Product Change Notification

1. ECR #: 219685
Notification #: 663

- SEM - .8MM TIGER EYE MICRO SOCKET
- SEML - .8MM TIGER EYE MICRO SOCKET

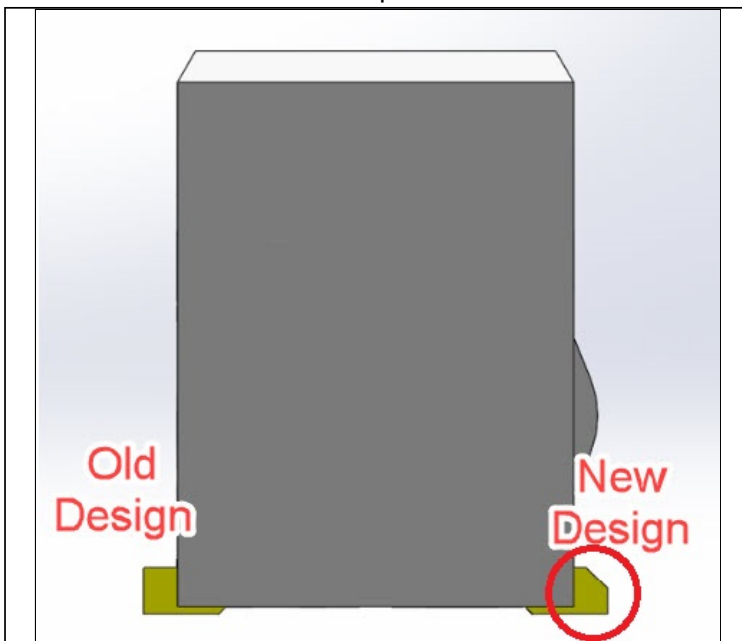
Small chamfer added to top side of solder tail.

Minor visual difference to the top corner of the solder tail.

Circled on the right is the new pin tail with the added chamfer.

This is a rolling change that has been made to improve mating clearances with Samtec's TEM connector for maximum material condition tolerance stacks. This is a Form/Visual change only, with no effect on Fit or Function. This change is also backwards compatible.
